DNFSB RECOMMENDATION 2000-1

IMPLEMENTATION PLAN

REVISION  
TO  
SECTION 5.1 HANFORD

November 2005

**Figure 1: Flow Path of Sludge Processing/Disposal Path**

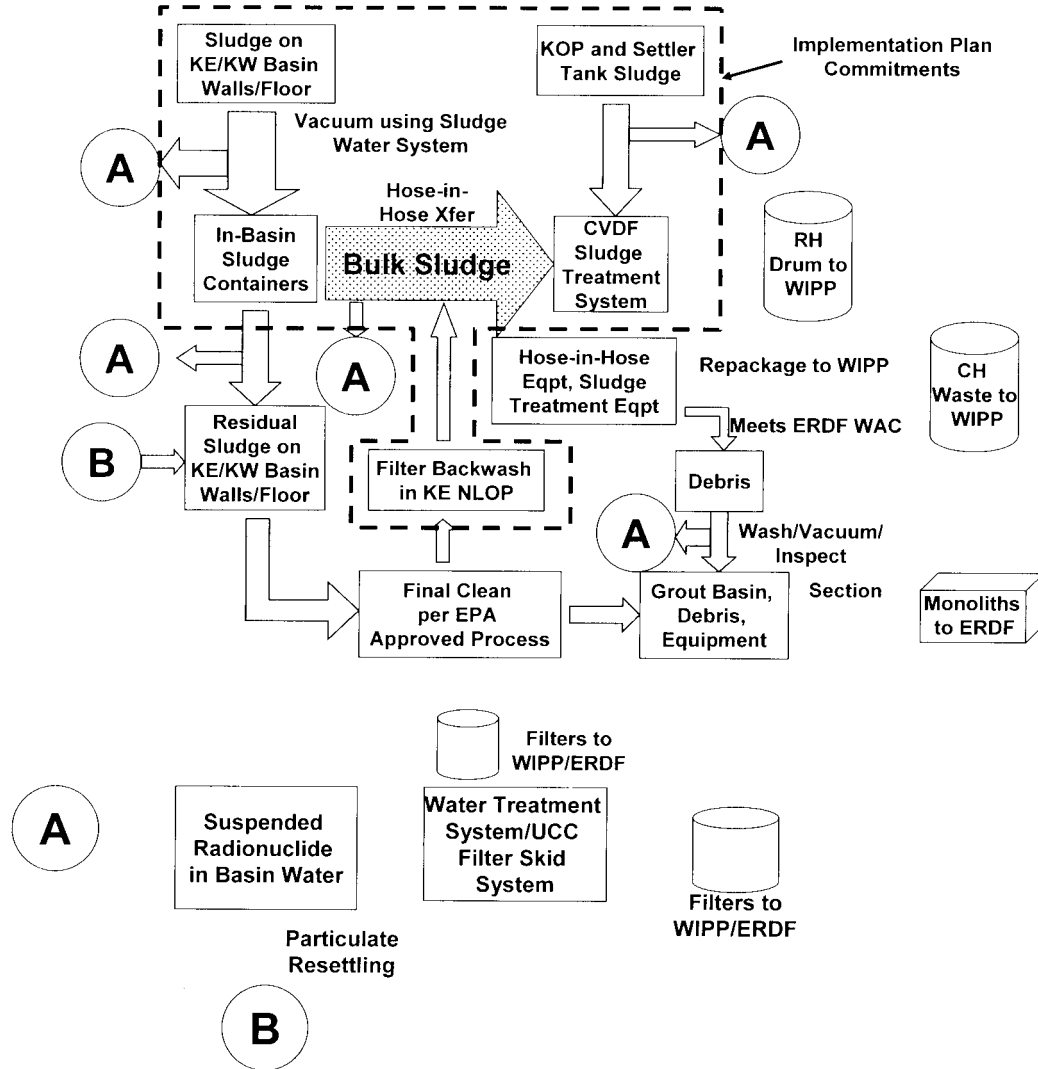
Once the final sludge removal process is complete, a measurement of the amount of sludge remaining is required. The targeted thickness of sludge remaining is 0.05 inch or less including resettled sludge. This thickness collectively corresponds to approximately one cubic meter of sludge on the basin floor. A maximum thickness of 0.1 inch may be allowable depending on other sources of sludge (sludge entrained in the concrete, sludge on the debris, etc). This is based on an assumption that the sludge is made up of 80 percent floor sludge and 20 percent canister sludge, which is a conservative assumption. The sludge thickness will be physically measured by an optical device using a process approved by the EPA. All sources of sludge are considered to ensure the grouted basin will meet the ERDF Waste Acceptance Criteria (WAC). Figure 1 illustrates bulk sludge and the disposition paths of the sludge in the K-Basins.
